DESCRIPTIVE REPORT

Field No. HY-12355 Office No. H-8200

General locality GULF OF MAINE

HYDROGRAPHIC SURVEY H-8200 (Hy-12355)

HY-12355
H-8200
Chart 71

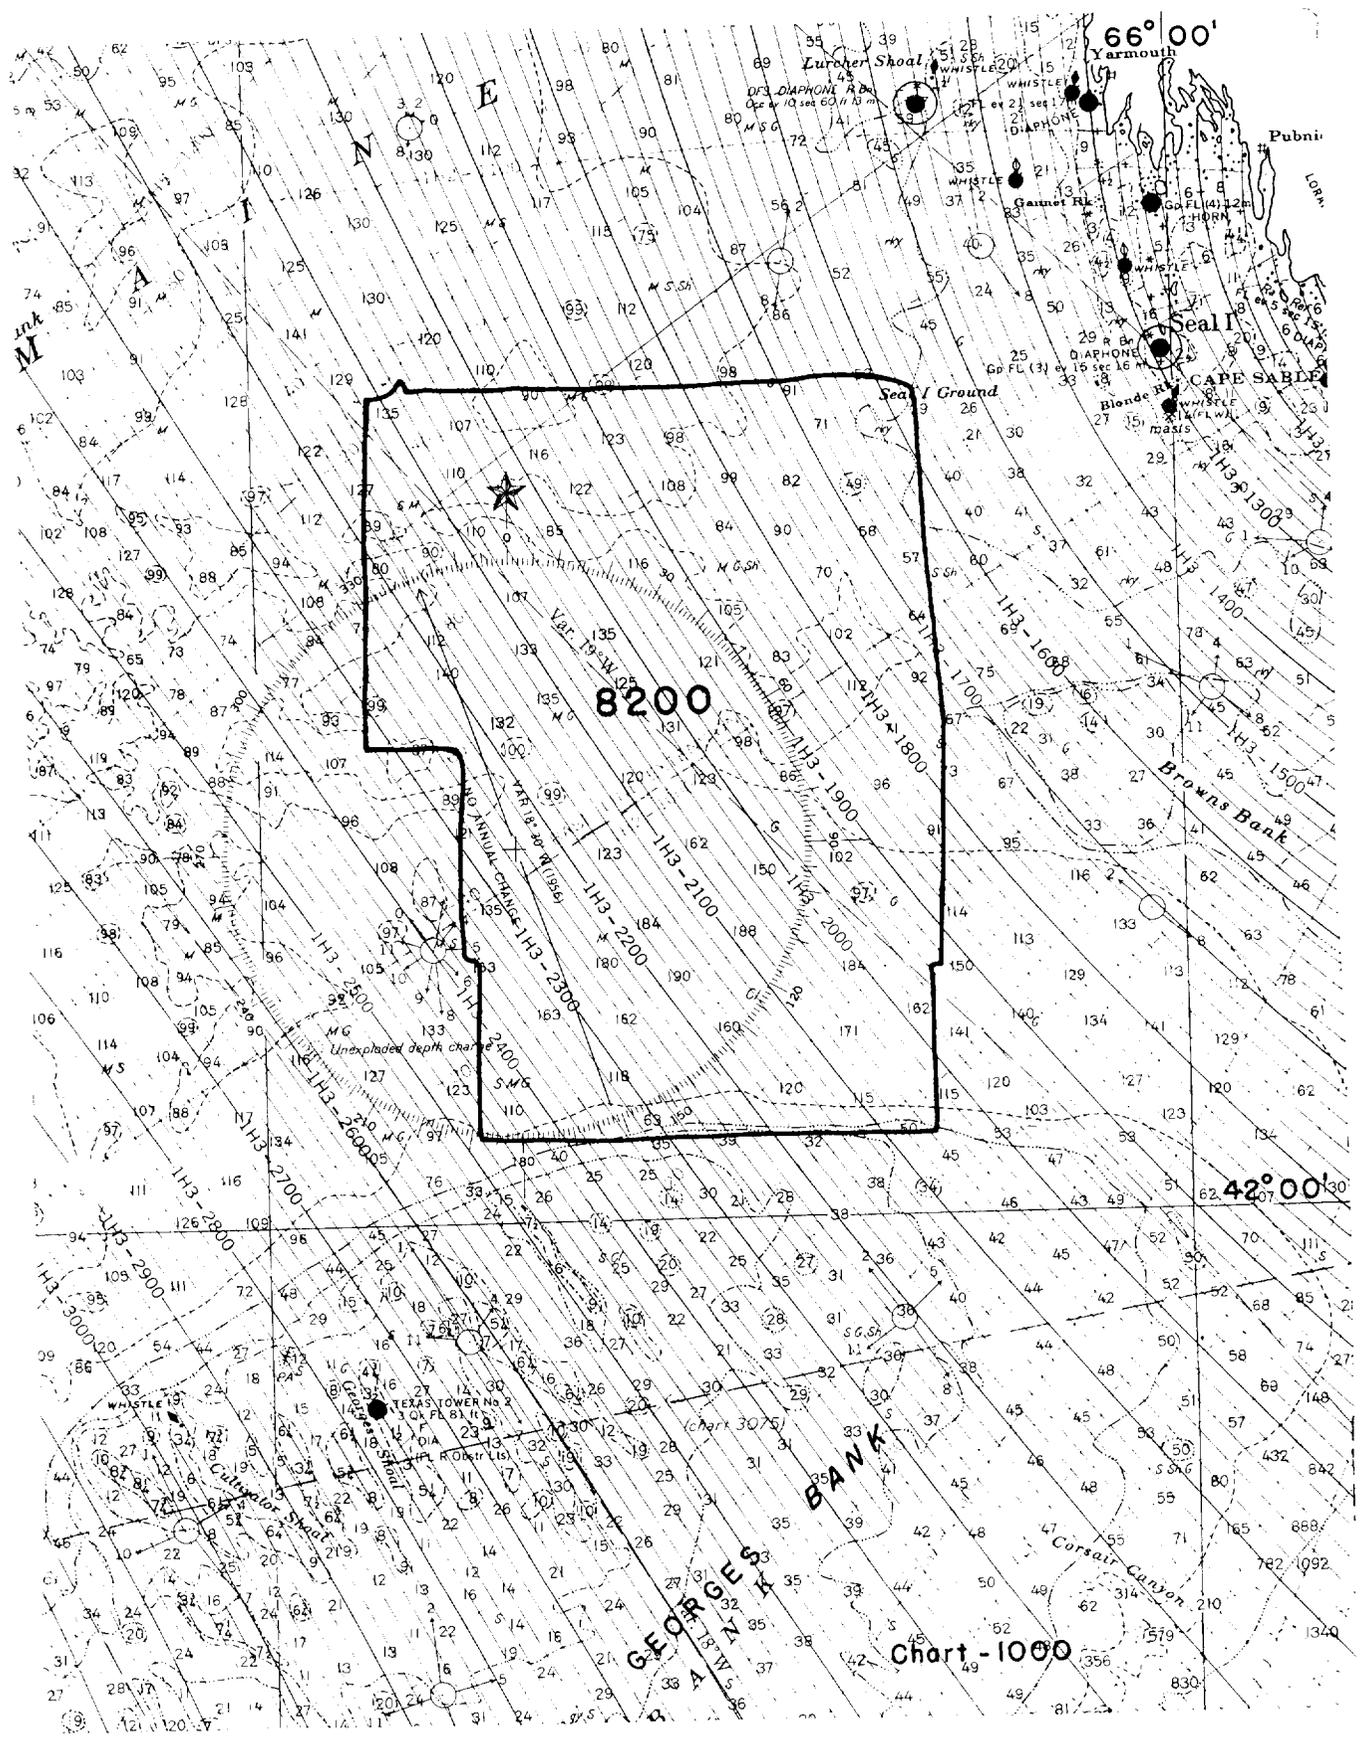
See the attached section of chart 71 showing comparative smooth sheet depths in red ink.
